हिन्दुस्तान पेट्रोलियम HP इंजीनियर्स इंडिया लिमिटेड (भारत सरकार का उपक्रम) ENGINEERS INDIA LIMITED (A Govt. of India Undertaking)	**Residue Upgradation Facility (RUF)** **EPCC-3 Package for** **Visakh Refinery Modernization Project (VRMP)**	L&T Hydrocarbon Engineering **L&T- CHIYODA LIMITED**
Title: ~~Data Sheet With~~ **GAD for Dock Leveller** (504-LZ-930 A/B) **Doc. No.: B016-RUF-LT-504-MP-GN-NTPL(1)-13002**		**Rev. No.: 00** **Page No: 1 of 4**

OWNER	:	**HINDUSTAN PETROLEUM CORPORATION LIMITED (HPCL)**
PMC	:	**ENGINEERS INDIA LIMITED, NEW DELHI (EIL)**
UNIT	:	**504**
PMC JOB NO.	:	**B016**
EQUIPMENT DESCRIPTION	:	**DOCK LEVELLER**
EQUIPMENT TAG	:	504-LZ-930 A/B
P. R. NO.	:	B016-RUF-LT-504-MP-PR-0014
VENDOR NAME	:	**NIHVA TECHNOLOGIES PVT LTD**
VENDOR DOCUMENT NO.	:	**NIHVA_20-21_0157**

DATE 31.05.21
SCALE 1:1
TITLE: ~~DATASHEET WITH~~ GAD FOR DOCK LEVELER (504-LZ-930A/B)
DEPT: DESIGN
DRN BY: SMS
CHK BY: VJ
APP BY: AK
PROJECT: L&T-RUF
PWO NO.:
DRG. NO.: B016-RUF-LT-504-MP-GN-NTPL(1)-13002
SH.1 OF 1
REV. 00
CAD REVISE THIS DRG. USING CAD SYSTEM ONLY FILE:

SECTION B-B
SCALE 1 : 15

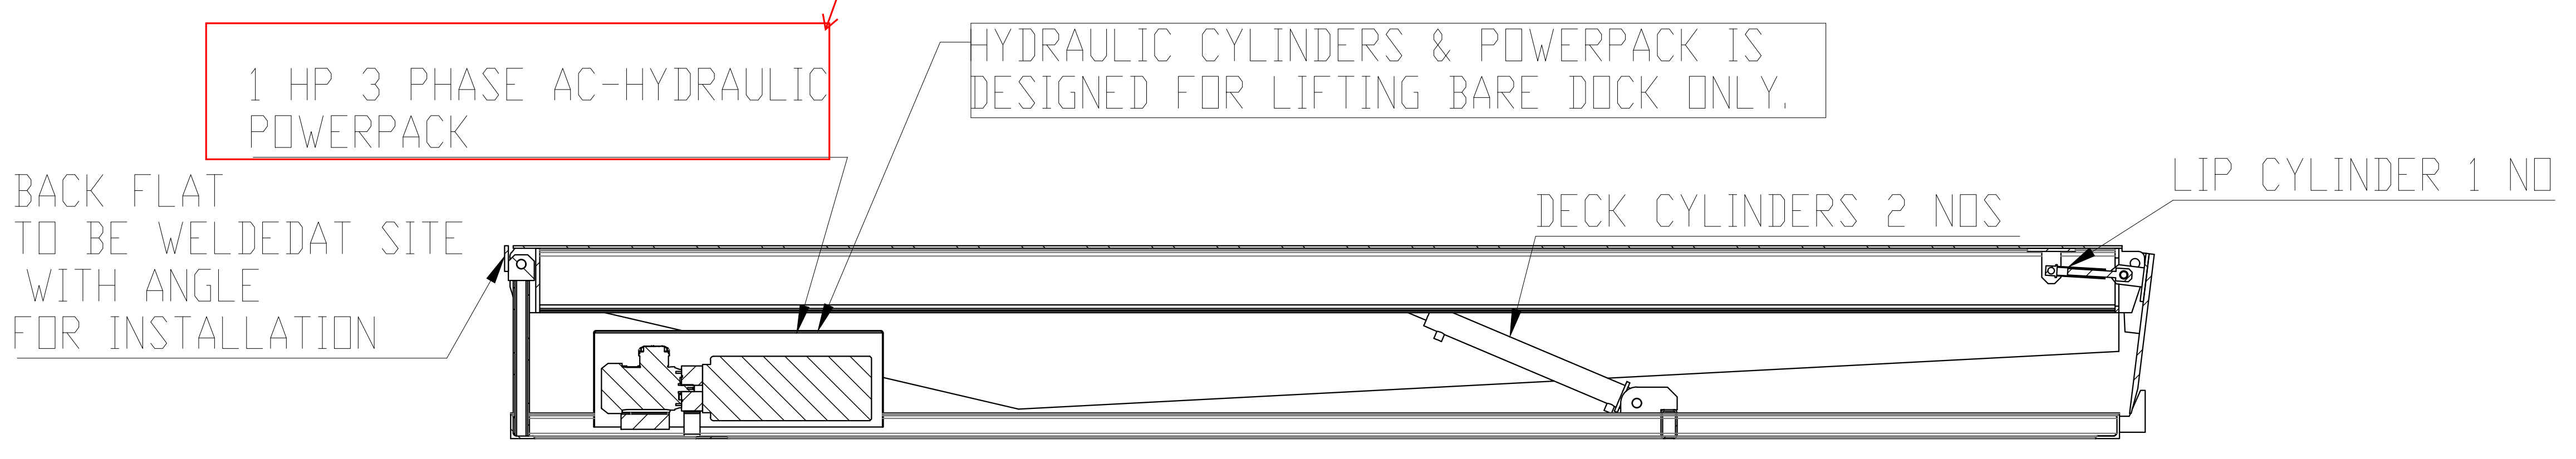
Is hydraulic power pack common for both deck cylinders & lip cylinder? If yes, please indicate clearly.

DECK UP HEIGHT - 600 MM

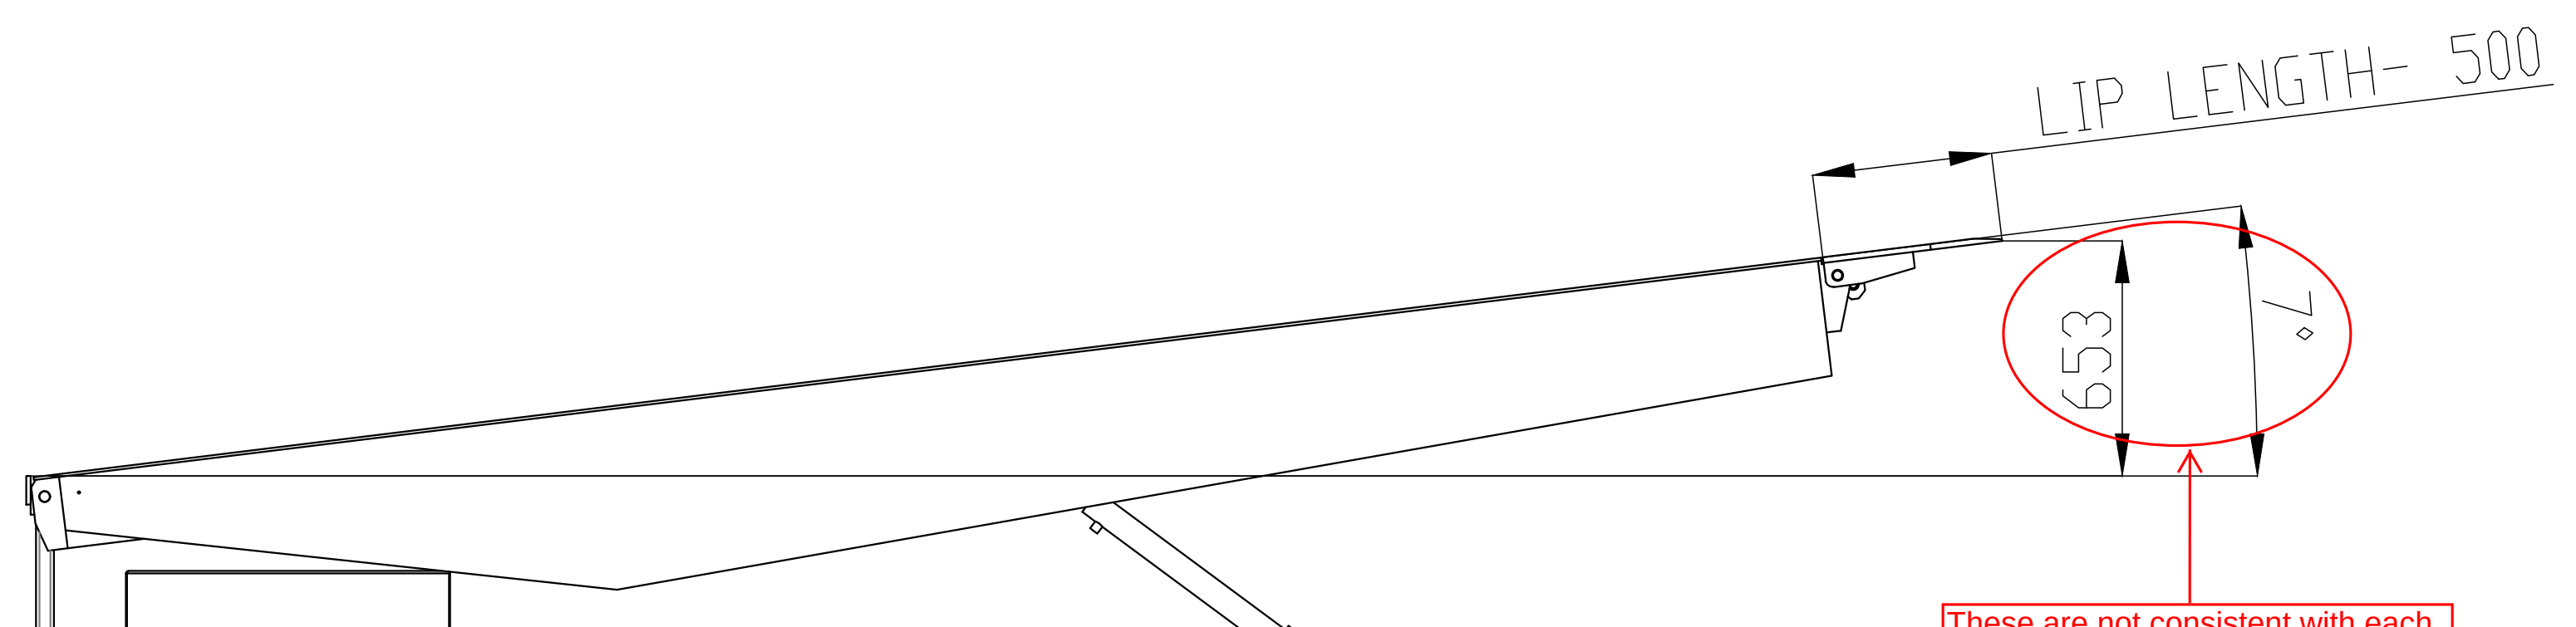
These are not consistent with each other. Please check & update. Maximum slope indicated in attached data sheet shall also be accordingly checked & updated.

DECK DOWN HEIGHT - 300 MM

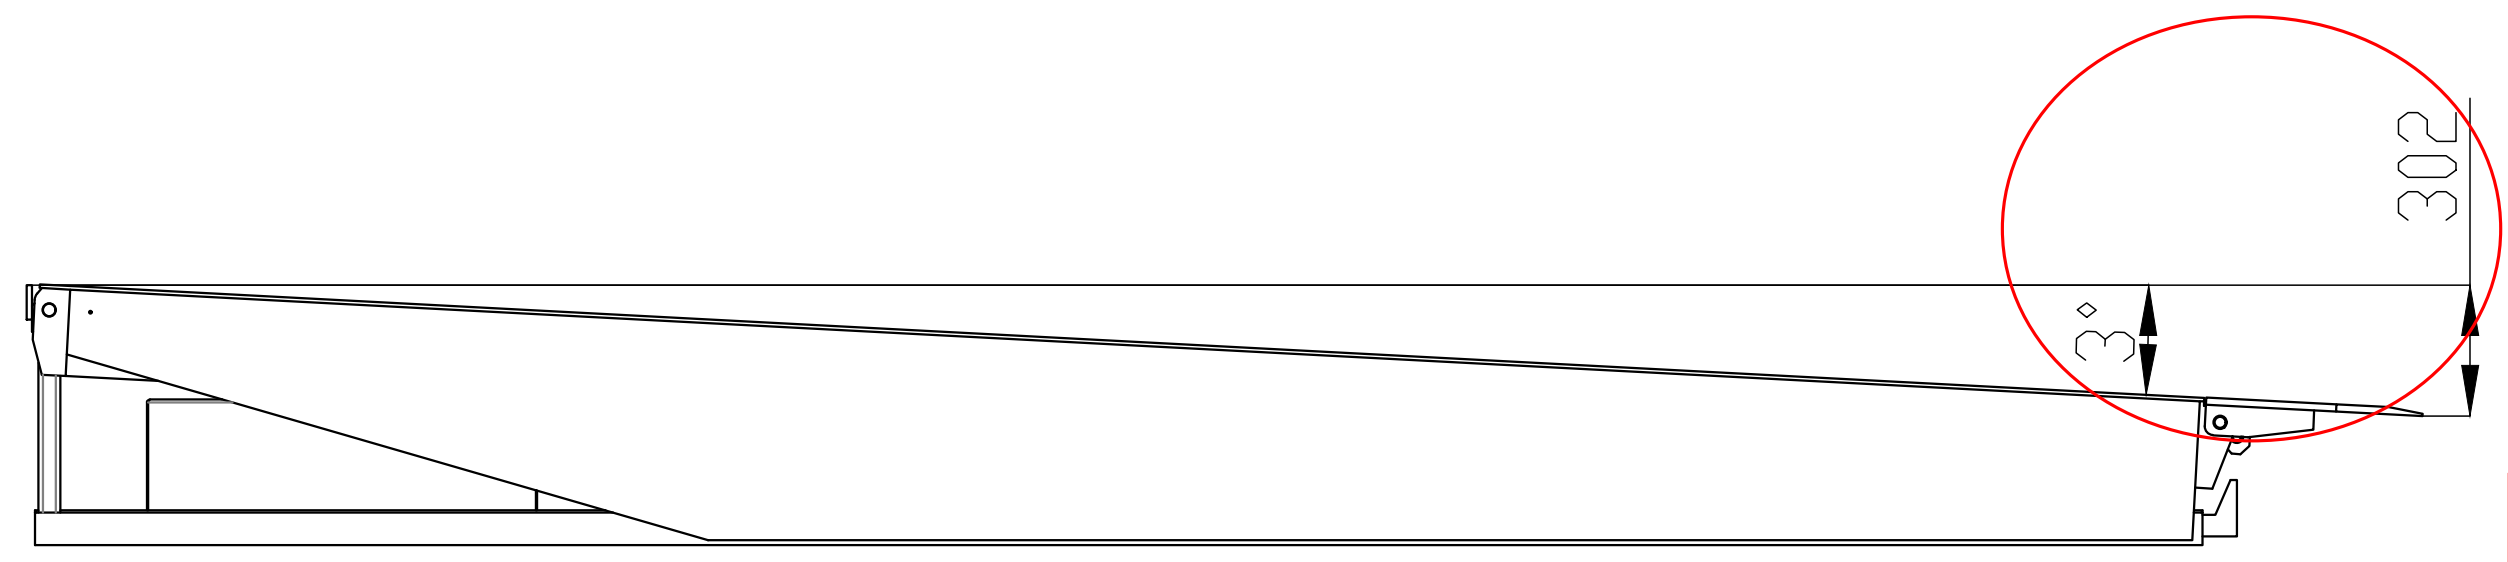
These are not consistent with each other. Please check & update. Maximum slope indicated in attached data sheet shall also be accordingly checked & updated.
